RE: Application Number MP 10-0006 (Pindimar Abalone Project)

Record of Objection:

Photo 1 of 5: Wetlands adjacent to development site

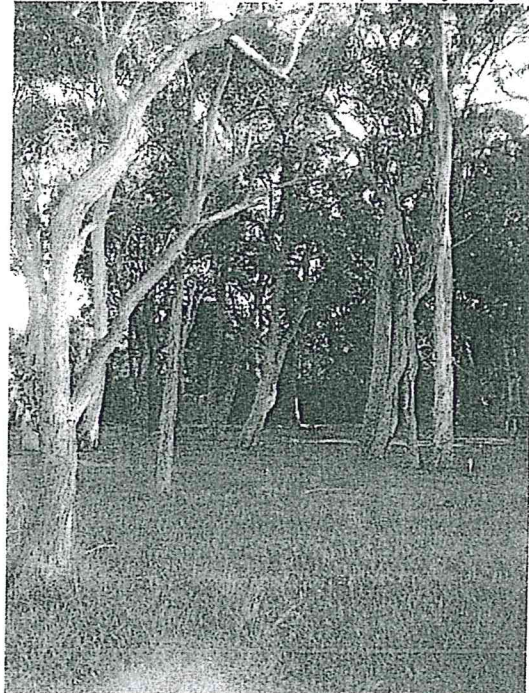
- h. The vegetation separating the development from the closest residents is not 'dense'; as stated in paragraph 1 EAR Page 38. *I recommend the minister, and/or his agent(s), visit the South Pindimar village, and the proposed adjacent development site to get a true perspective.*

The three photos below depict the wetlands, creek and cleared sites that sit, in sequence, between the proposed development and residents homes.

Photo 3 of 5: Cleared private property adjacent to the creek.

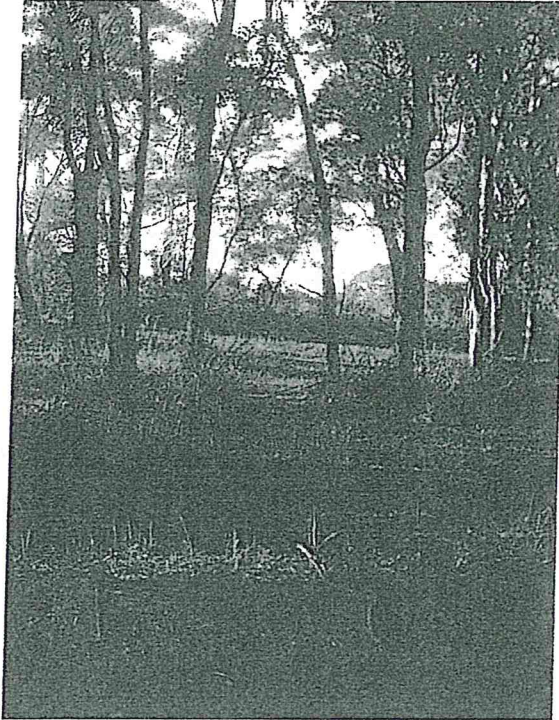
- i. The vegetation in front of proposed 24 hr pumps has been cleared to the waterfront and is predominantly patchy with tall trees with canopies to focus the noise out across the water directly into water-front homes.
